**CITY OF DOVER, DELAWARE
PLANNING COMMISSION
Monday, September 15, 2025 at 6:00 PM**

AGENDA

Plan Title: Lands of Wyoming, LLC and Functional Properties, LLC (Ekaman Subdivision): Conceptual Subdivision Plan, SB-25-02C

FILE #: S-25-01 Revised

MARK	DATE	DESCRIPTION
1	8-1-25	CITY OF DOVER PLANNING COMMISSION UPDATE
PROJECT NO.: 2024314.00		
DATE: 12-05-24		
SCALE: 1" = 20'		
DRAWN BY: A.J.S. / PROJ. MGR.: M.J.H.		
SHEET		
C-101		
COPYRIGHT 2024

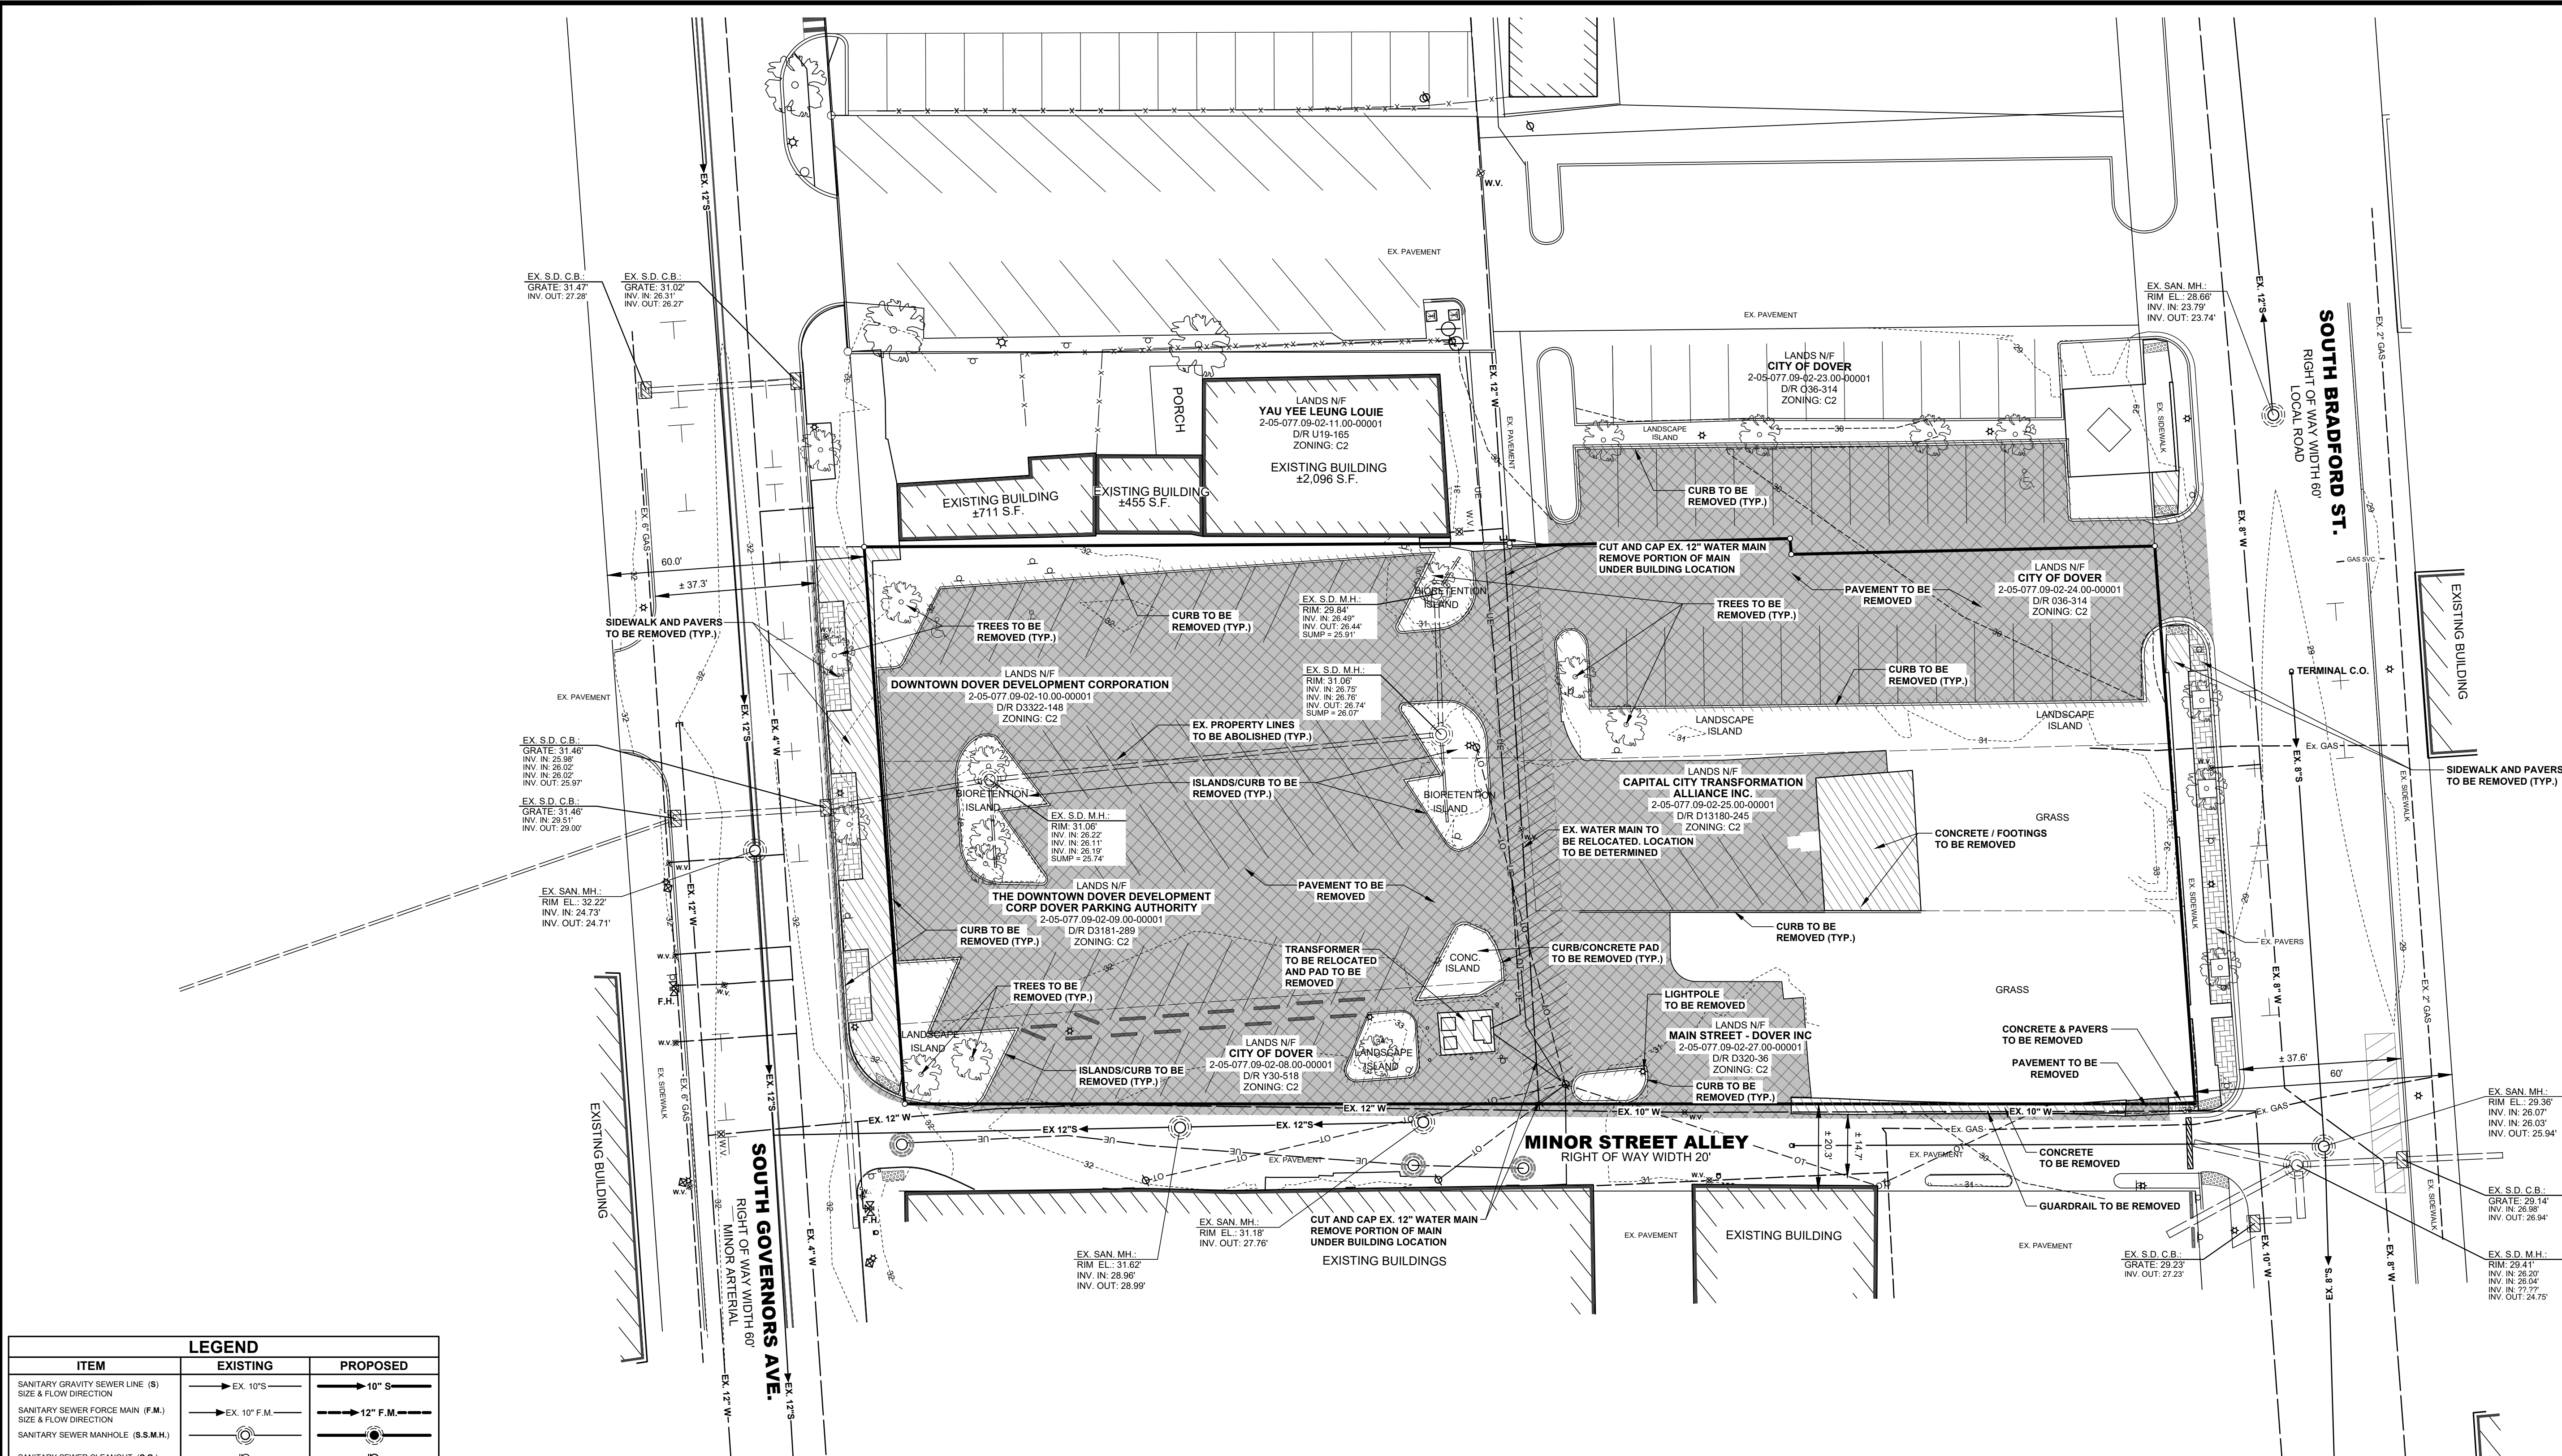
- 5) Sheet C-101 – Existing Conditions and Demolition Plan:
 - a) Per the Existing Conditions and Demolition Plan, three bioretention islands are being removed. The applicant should provide a Stormwater Management Plan that identifies solutions for capturing and treating added stormwater quantities from additional lot coverage and the demolition of bioretention facilities.

C-202

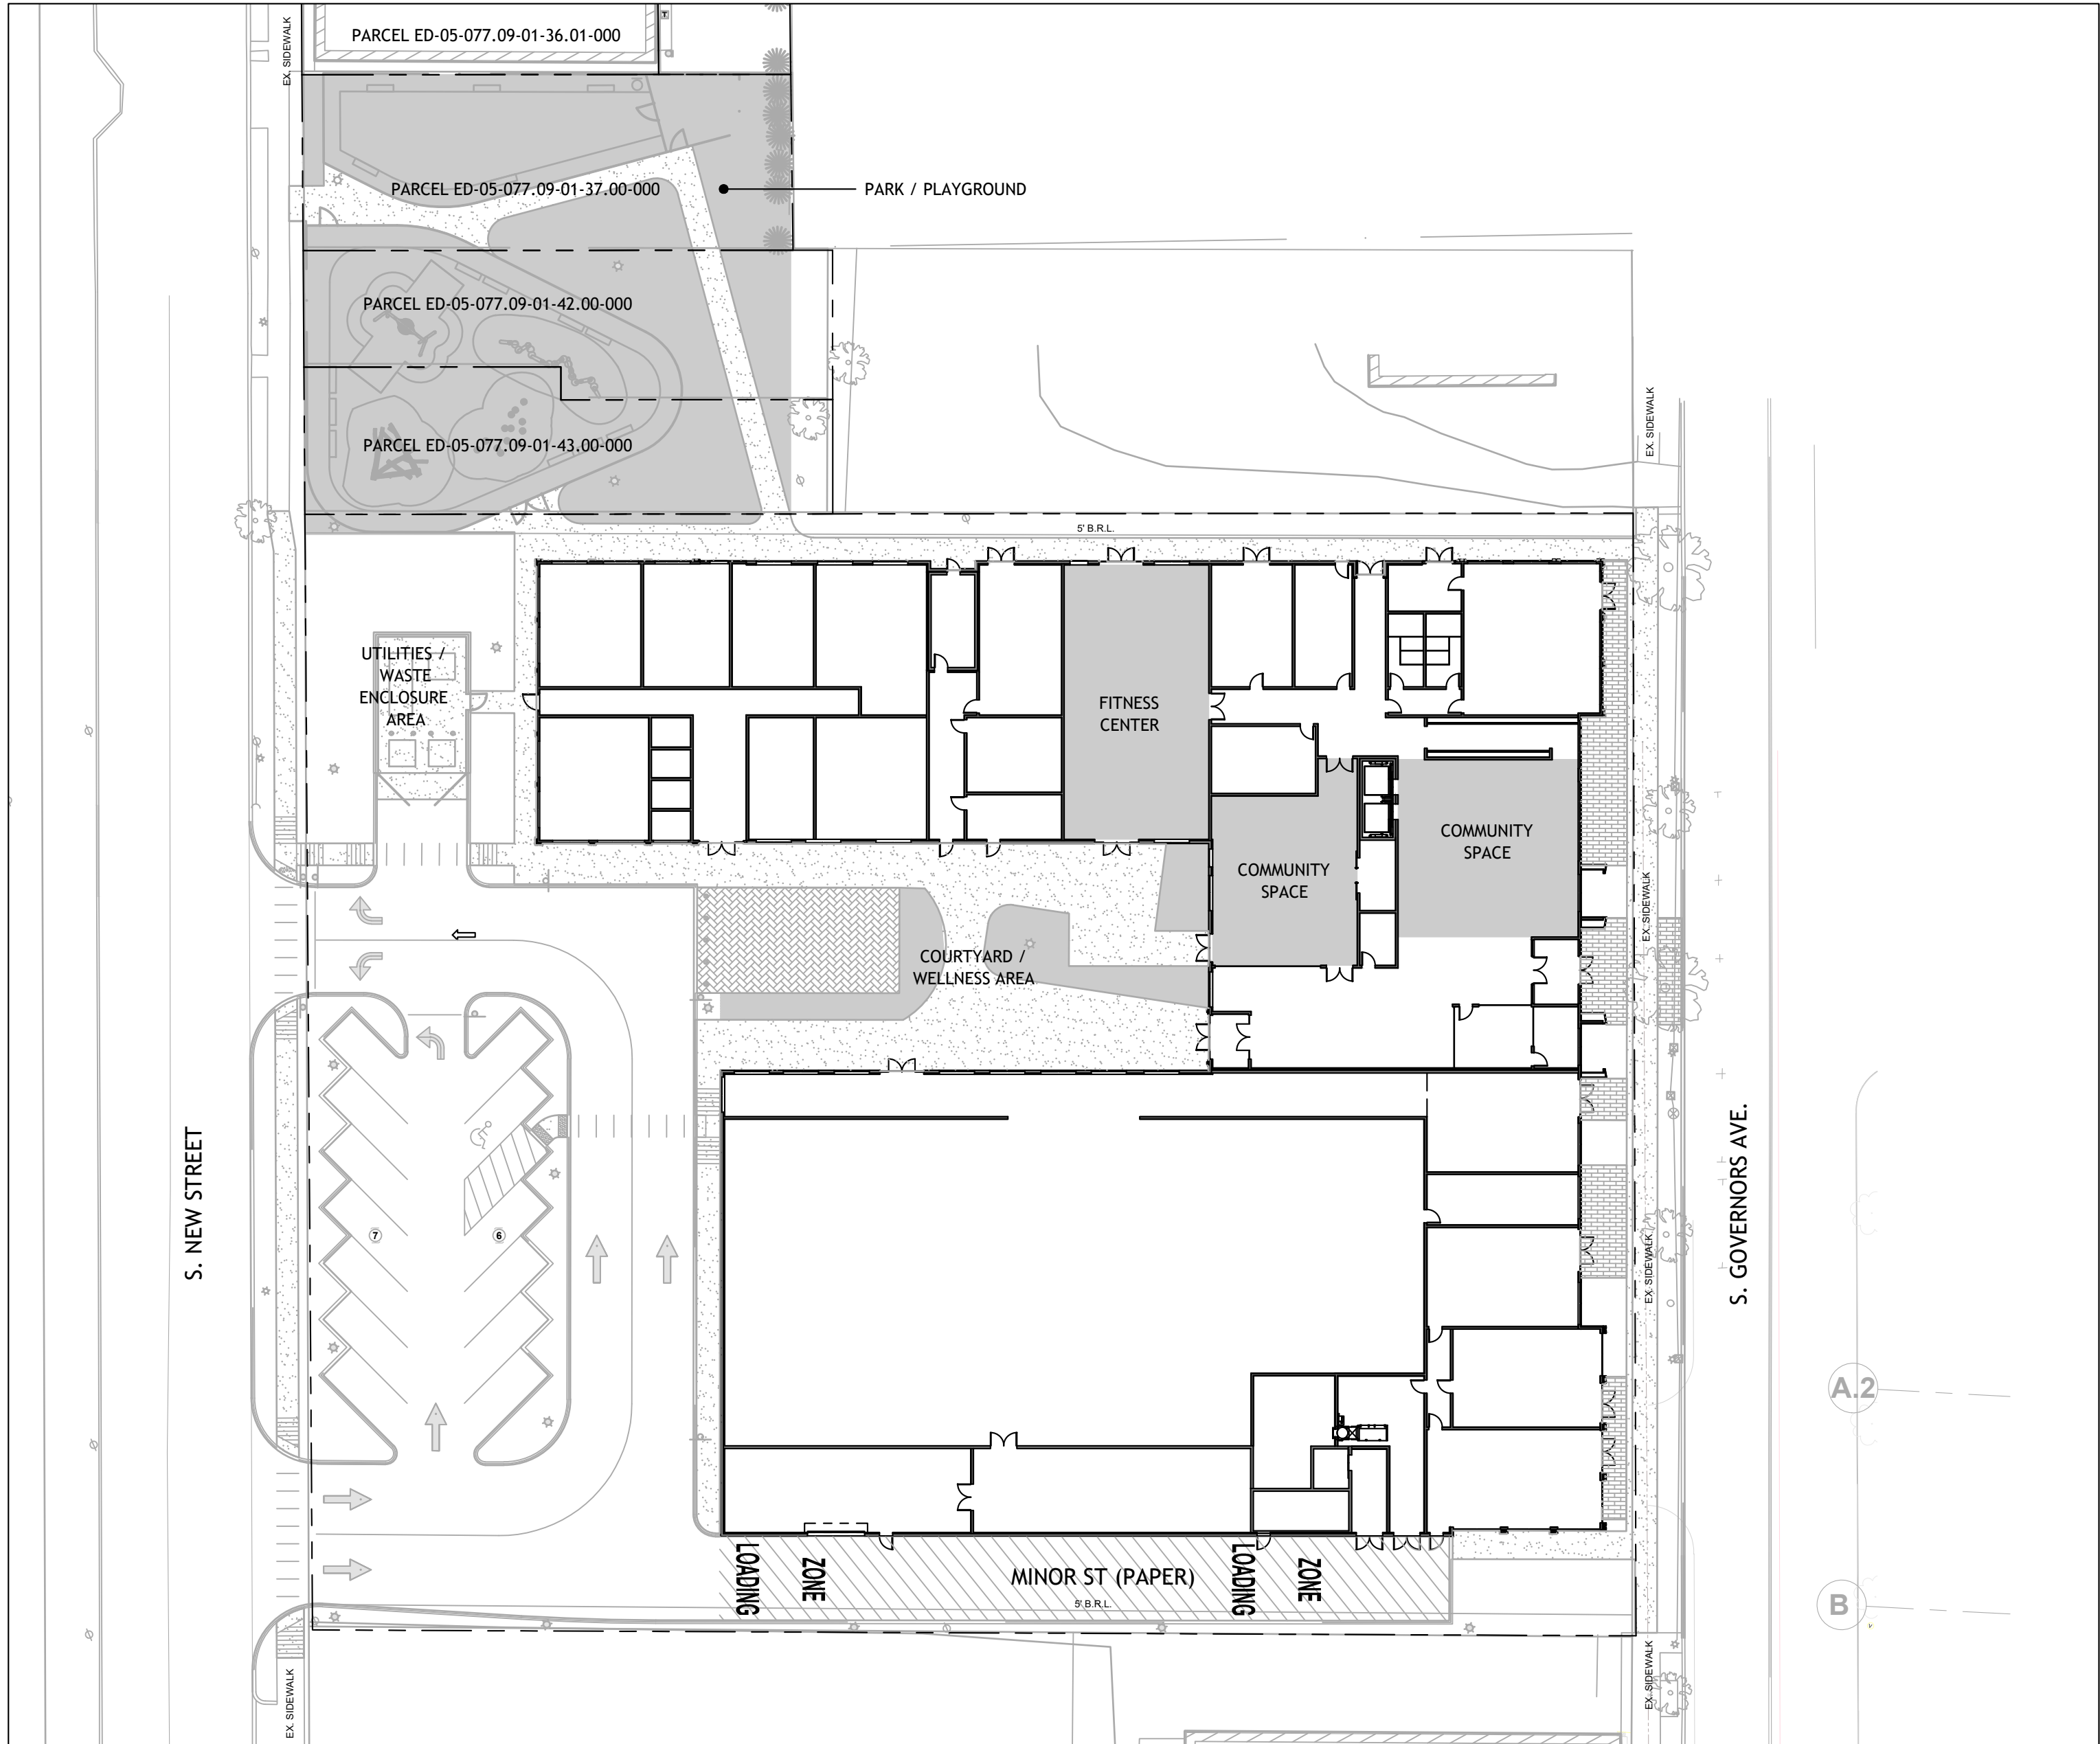
- 8) Landscape Plan (as Updated 9/4/2025):
 - a) On Sheet Z-100, add the signature box for the signature of the landscape architect.
 - b) Ensure tree planting locations do not conflict with sidewalk paving and comply with separation distances from utilities. Compare to Site Plan sheets.
